Response to Heritage Comments

Land west of A6, north of Buxton, Derbyshire

Date: 17/02/2025 | Pegasus Ref: P24-1678

Derbyshire Planning Ref: HPK/2024/0467

Plate 1: LiDAR data showing agger and ditch

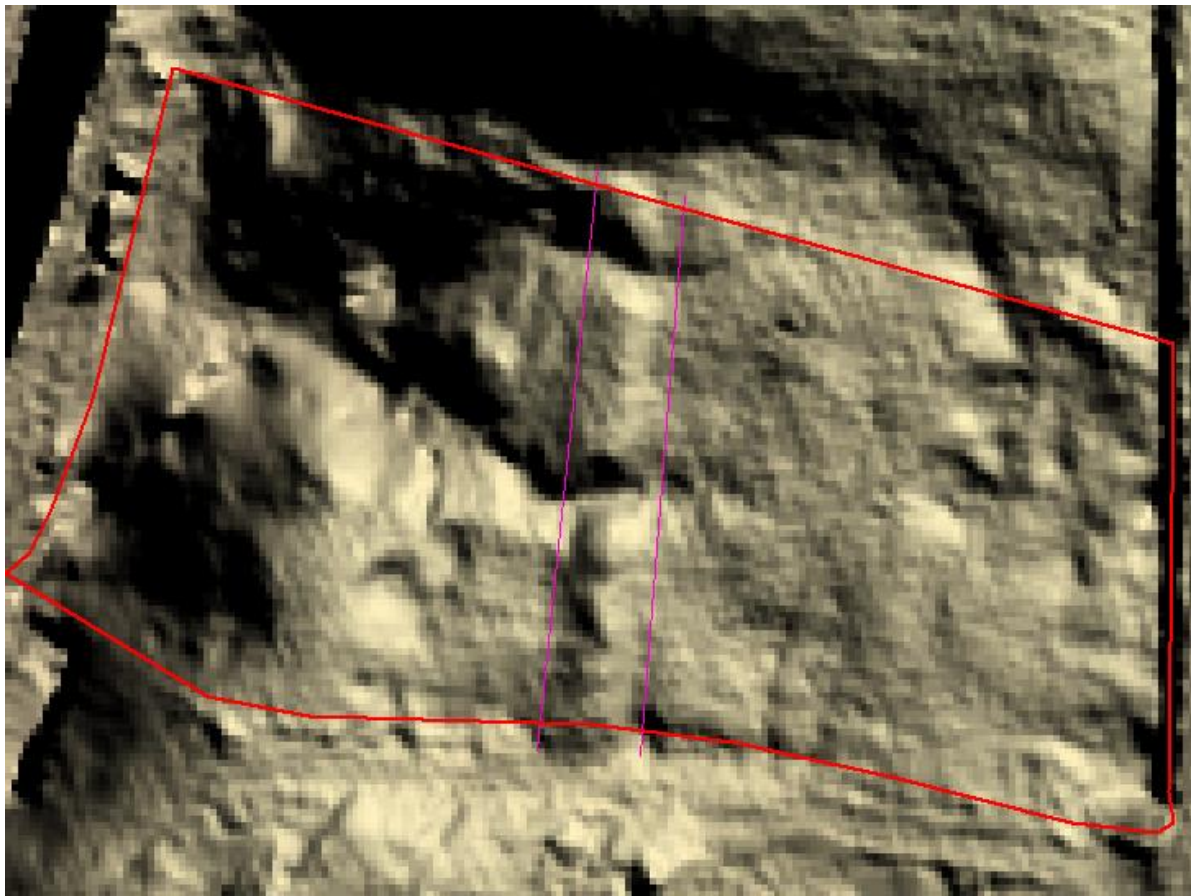
- 2.1. Following the receipt of the Officer's comments a detailed review of the potential areas of conflict between the earthwork remains of the Roman road was undertaken so that a revised design could be developed in response.
- 2.2. The LiDAR data covering the site indicated the alignment of the upstanding agger of the Roman road and suggested the presence of an adjacent ditch on the eastern side (Plate 1). The alignment and extent of the earthwork is marked in pink.

Plate 2: Initial Design overlain on LiDAR data (with road marked in pink)

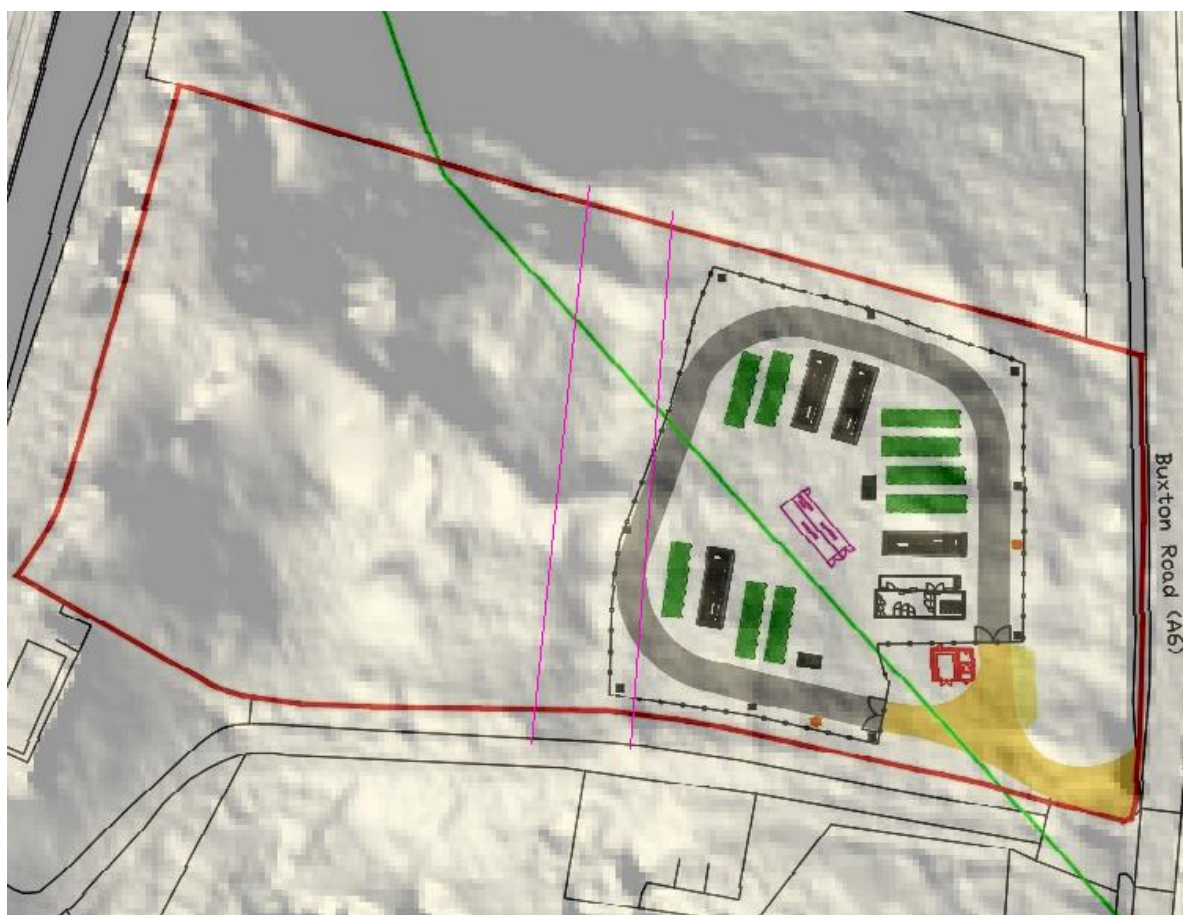
- 2.4. The initial design had been developed to avoid the extent of the road remains as identified by the geophysical survey (Plate 4). However, the disparity between the LiDAR and geophysical survey data has meant that a clash between the access road and boundary fence and the earthwork remains of the agger had not been identified within the initial layout.
- 2.5. The disparity between the agger and the geophysical survey results is likely to indicate that some of the roadstone within the road had been disturbed as a result of quarrying the material for alternate uses following the abandonment of the road. The apparent extent of disturbance to the earthwork and its immediate surroundings is also clear in the LiDAR data.

- 3.1. In response to the identified conflict between the proposed layout and the Roman road a revised design has been prepared (Plate 5). This has removed the south-western BESS unit and realigned the western elements of the access road and boundary fence to allow a 5m buffer between the proposed development and the Roman road.

Plate 5: Revised Layout with Agger (marked in black) and 5m buffer (marked in blue)

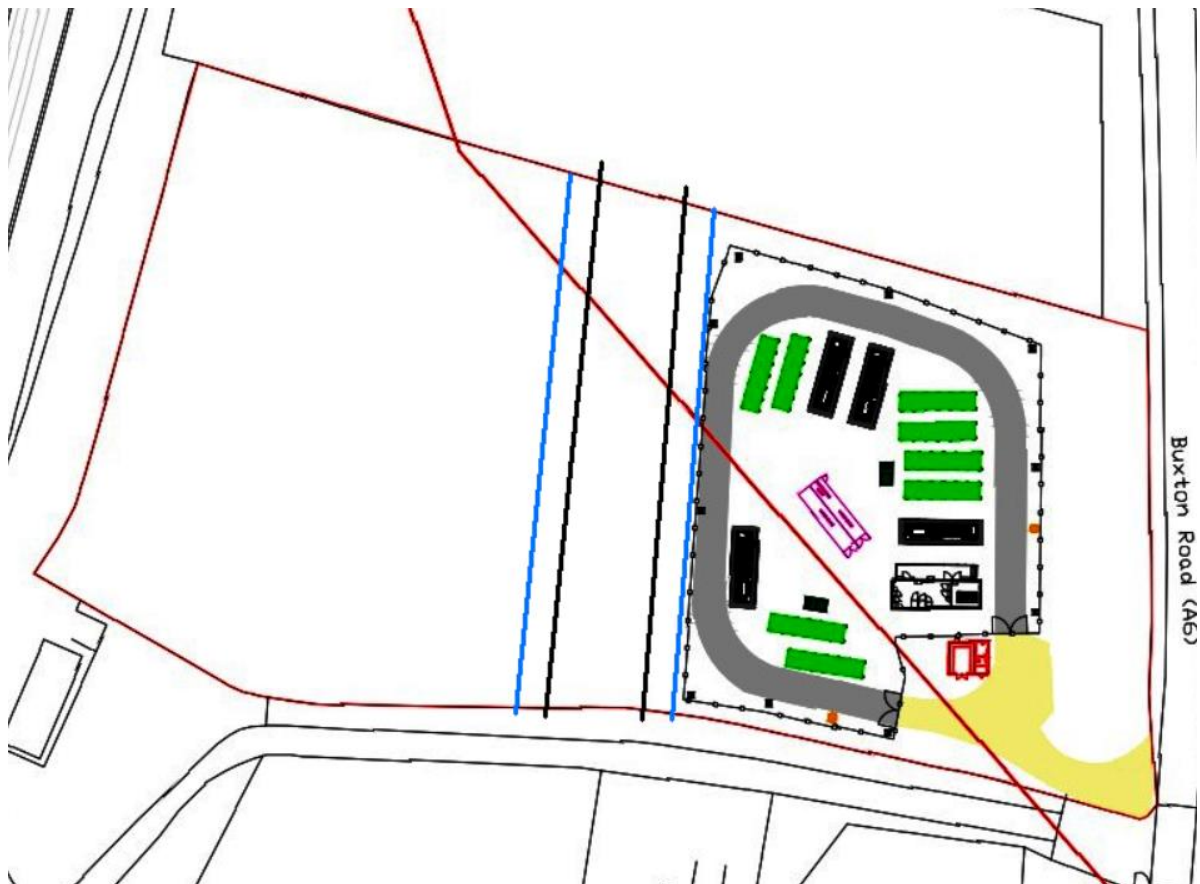
- The extent of the existing earthwork agger should be marked on development plans. An appropriate buffer to the edge of the earthwork from any part of the development should be at least 5m – this would usually cover the extent of any side ditches and was the buffer applied by Historic England in relation to the scheduled agger at Brassington Lane, Old Tupton. The buffer must be shown and quantified on the development plans.

- 3.2. The revised design has taken account of the extent of the identified Roman road remains, as shown by both the LiDAR data and geophysical survey and applied a 5m buffer in relation to both the BESS compound and the proposed landscape planting associated with the scheme.
- 3.3. The approach adopted is precautionary to ensure that the asset is protected during both construction and operation.

Plate 6: LiDAR data showing areas of quarrying (marked in orange) that affect the agger

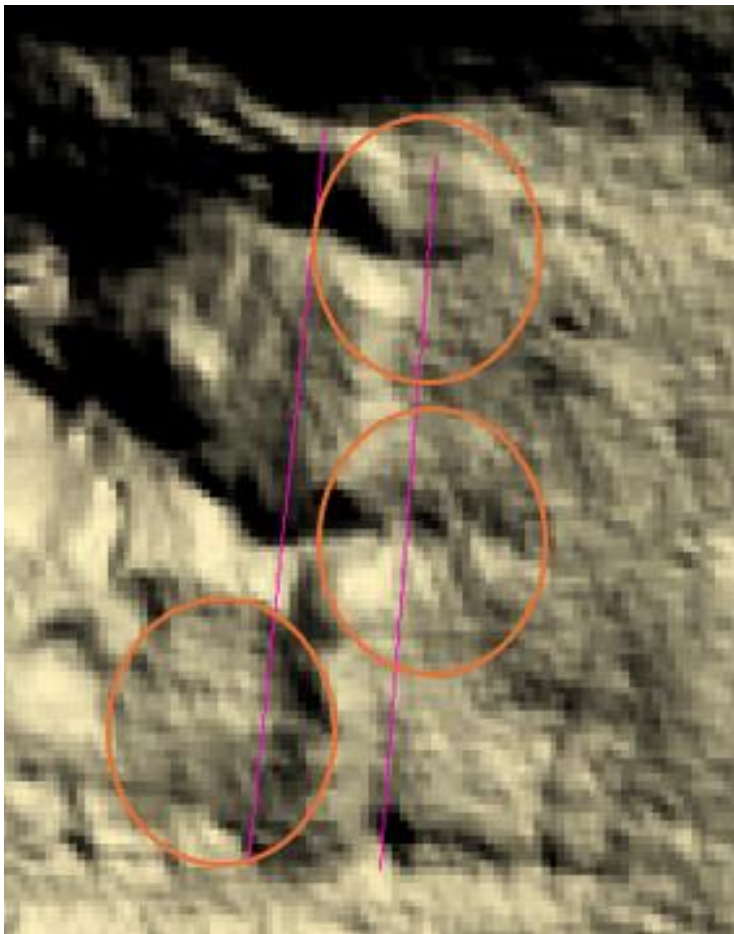
- 5.2. Whilst the Officer has suggested that the section of Roman road within the site is sufficiently well-preserved to have significance commensurate with a scheduled monument the quote from the selection criteria indicates that the removal of roadstone for hardcore would be likely to reduce the significance of an asset to below the threshold for designation.
- 5.3. With regard to the length of agger within the site it is acknowledged as a visible earthwork, however there is clear evidence of the road surfacing having been quarried for material both in terms of visible evidence of quarrying activity (Plate 6) and also in terms of the evidence provided from the geophysical survey results which showed stone to the east of the surviving agger.

- 5.4. Given the scale of disturbance to the length of agger within the site it is considered unlikely that the asset would be deemed to retain sufficient significance to merit designation as a scheduled monument. Furthermore, to the south of the site there is a better-preserved length of the same road which would be a more appropriate representative sample should a section of the road be deemed suitable for designation.
- 5.5. Therefore, it is considered that the remains of the Roman road within the site are a non-designated heritage asset of regional significance they do not meet the high bar required for such an asset to be considered of demonstrably equivalent significance to a scheduled monument. As such NPPF footnote 75 and paragraphs 212–215 would not apply.
